ADMINISTRATIVE AMENDMENT

File # D8AA-1001 Project # 1000390

PROJECT TITLE
VENTANA STORAGE UNITS
SW CORNER OF UNIVERSE & PASEO DEL NORTE
ALBUQUERQUE, NM

OVERALL SITE PLAN

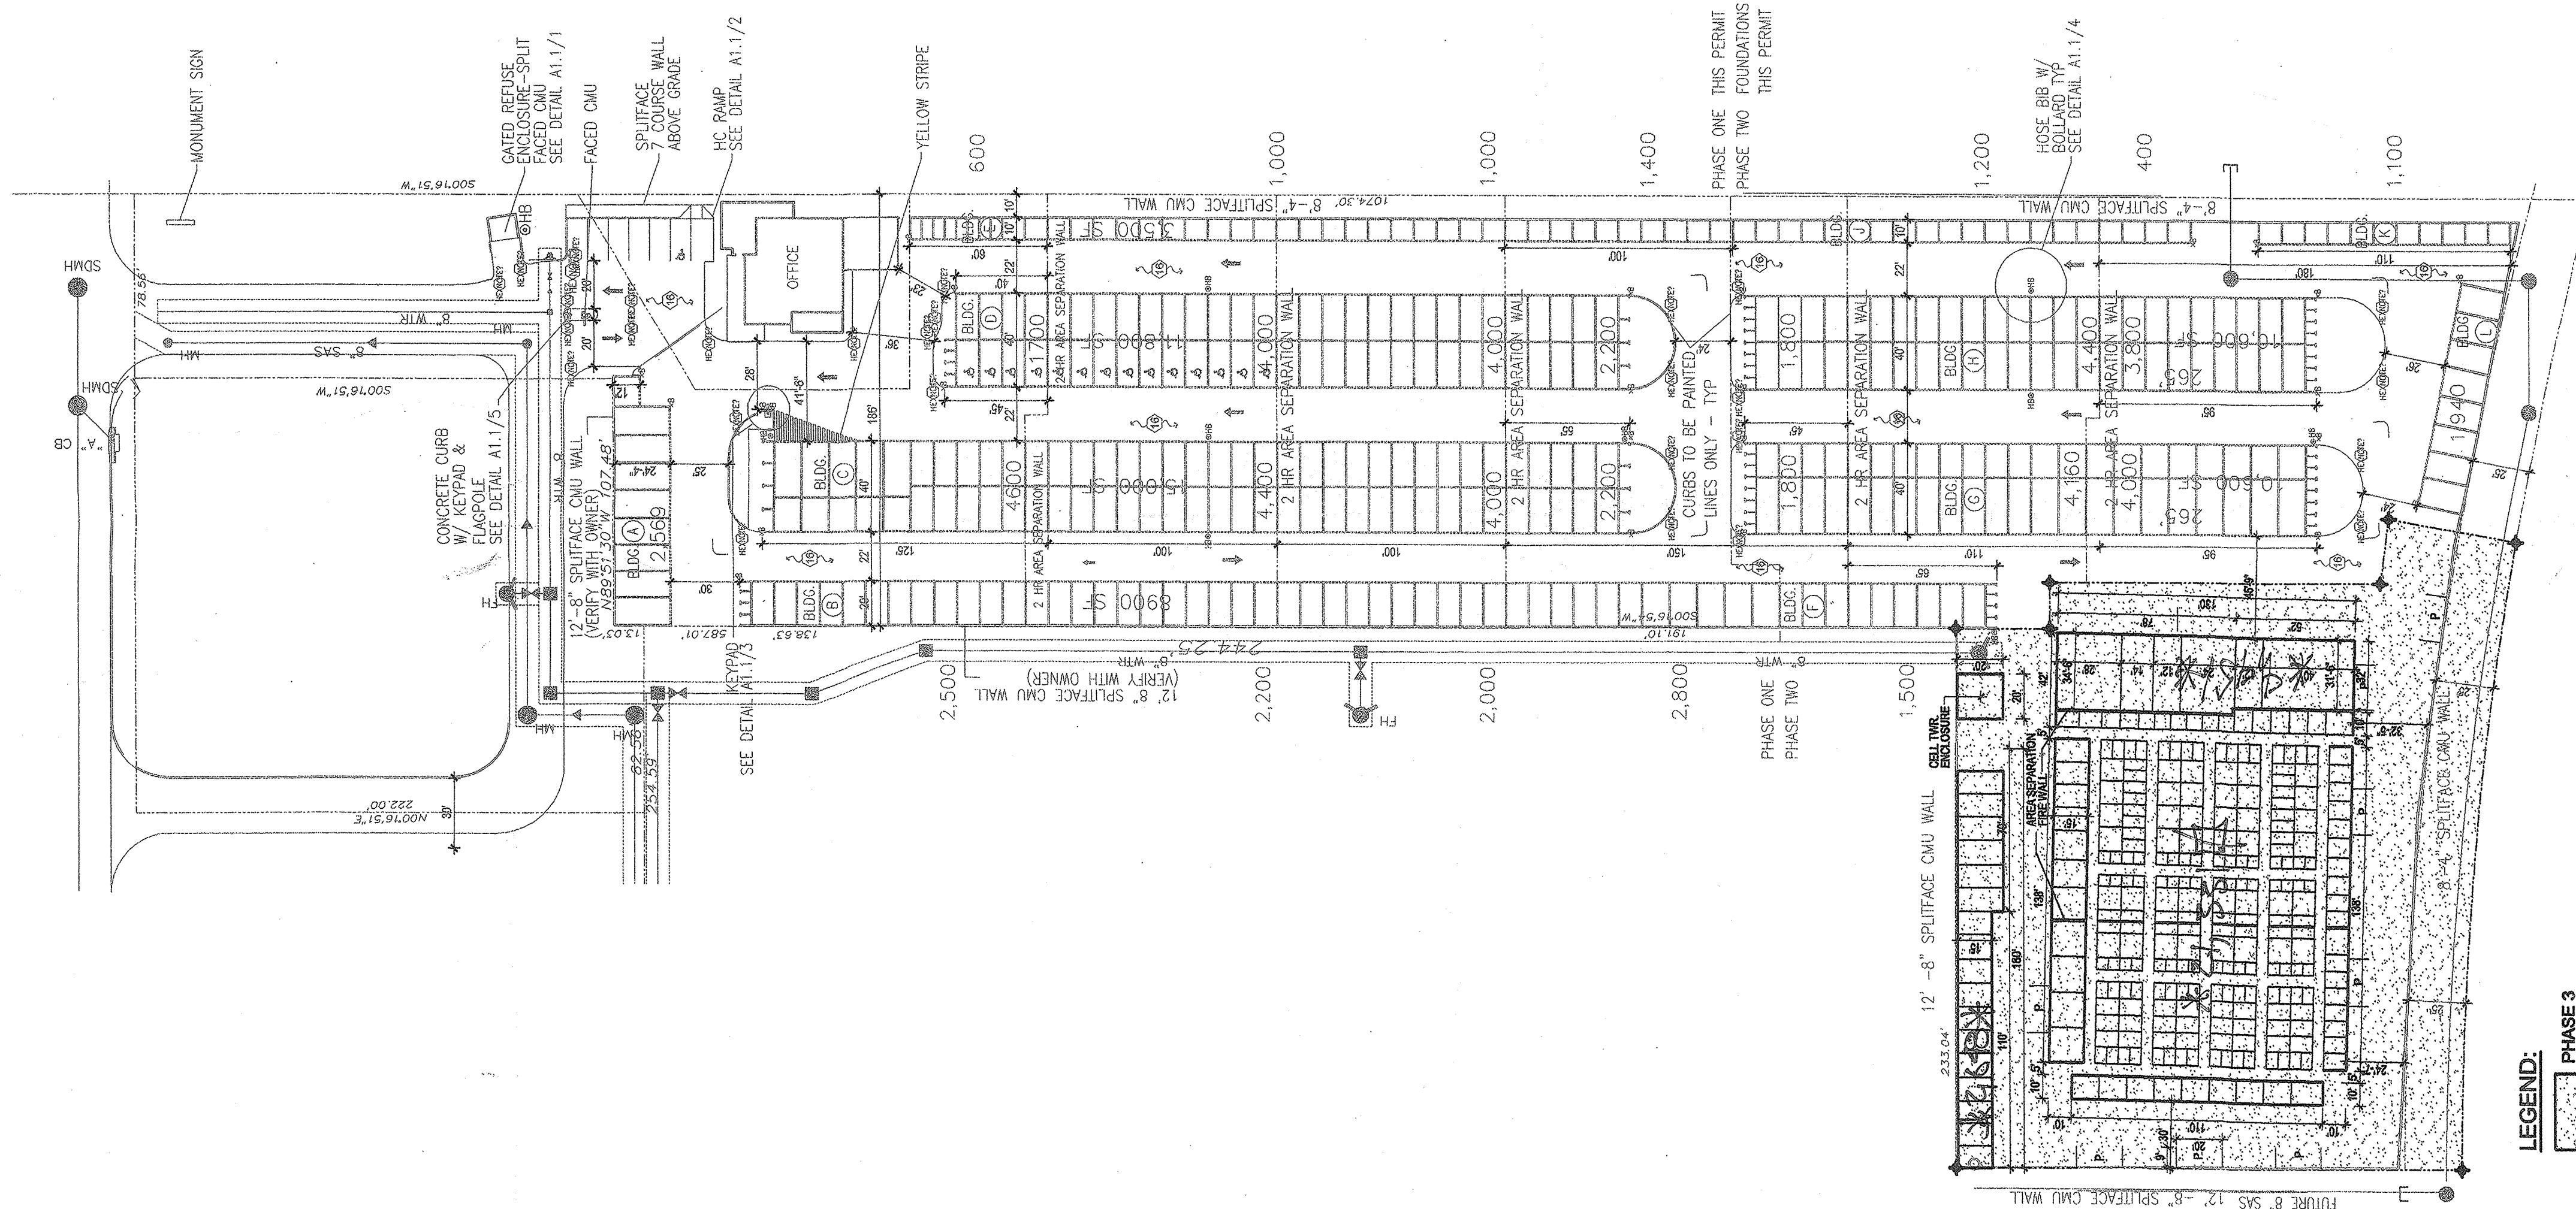
Replace boat/RV parking
with self-storage building.
